April 3, 2003

RE: STANTON A COMBINED CYCLE; PERMIT # 0950137-002-AC (PSD-313)
CEM AND STARTUP REVISIONS

Typical
PG7241(FA) Nox lb/h Vs %Output
Distillate Fuel

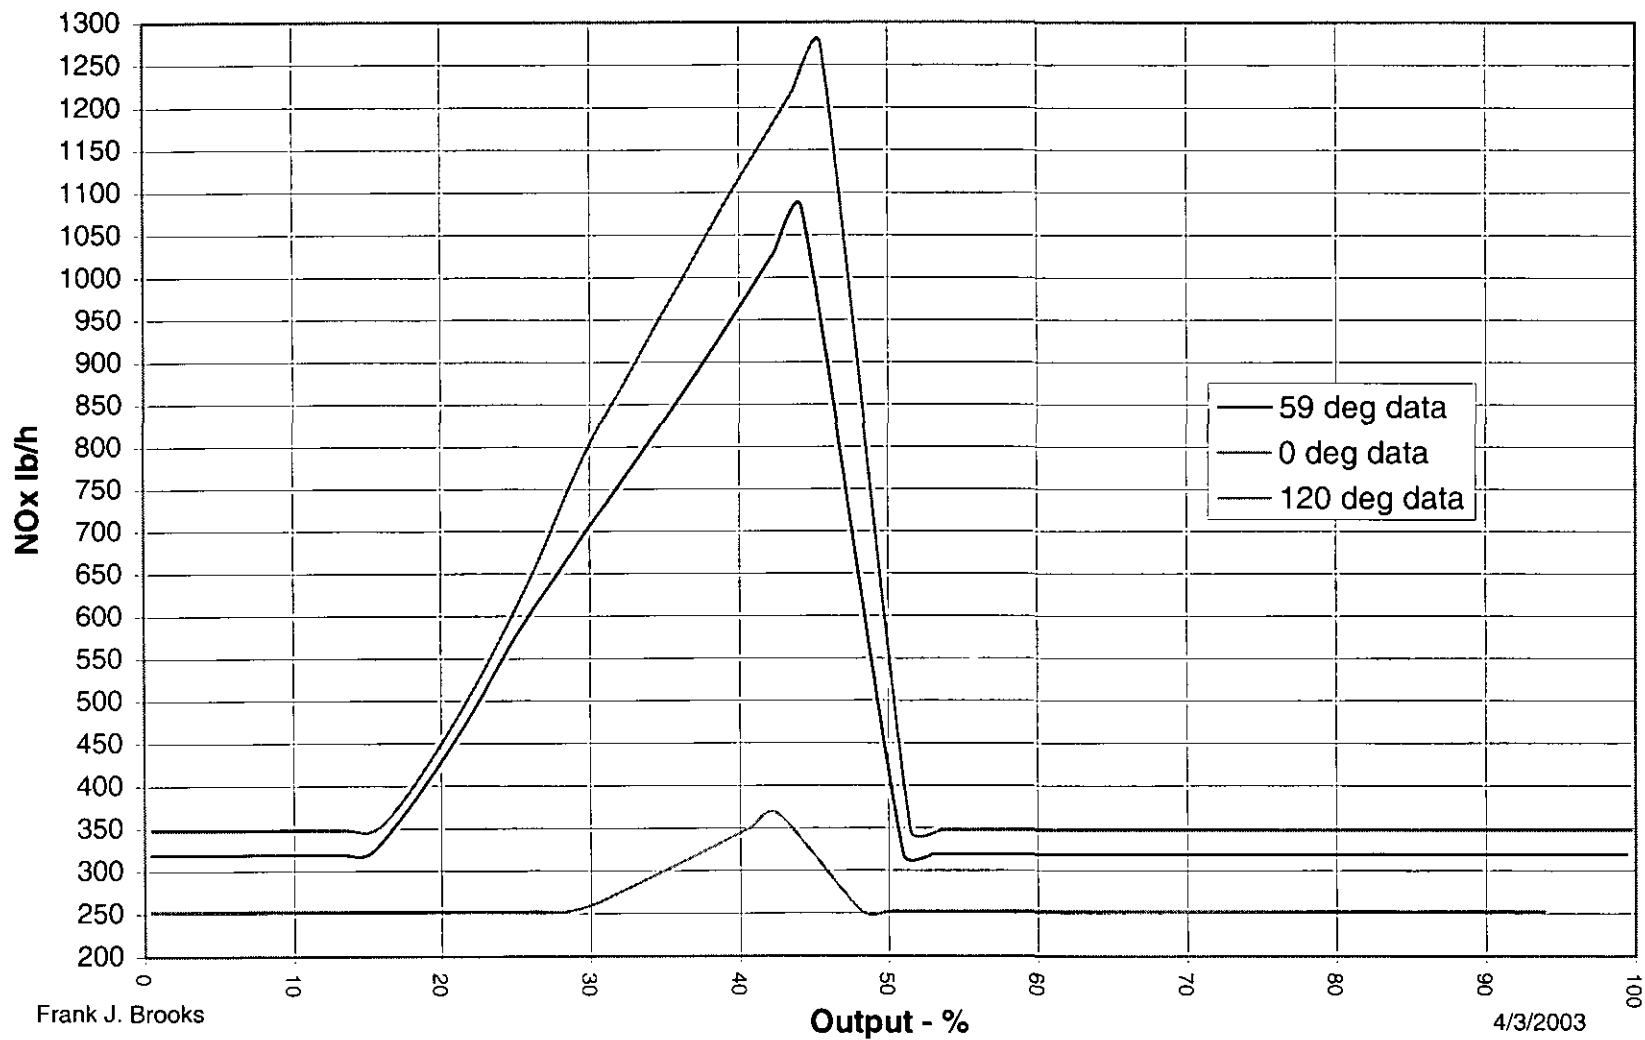
- a) During any calendar day in which a start-up or shutdown occurs with natural gas as the exclusively fired fuel, an alternative NO_x limit of 127 lb/hr (370 lb/hr if fuel oil is fired during the calendar day) on the basis of a 24 hour average shall apply. The 24 hour average shall be based on all available data excluding calibration data.

Highest estimated startup NOx emissions based on GE data extrapolated for 12 hours startup on oil is = **370 lb/hr**
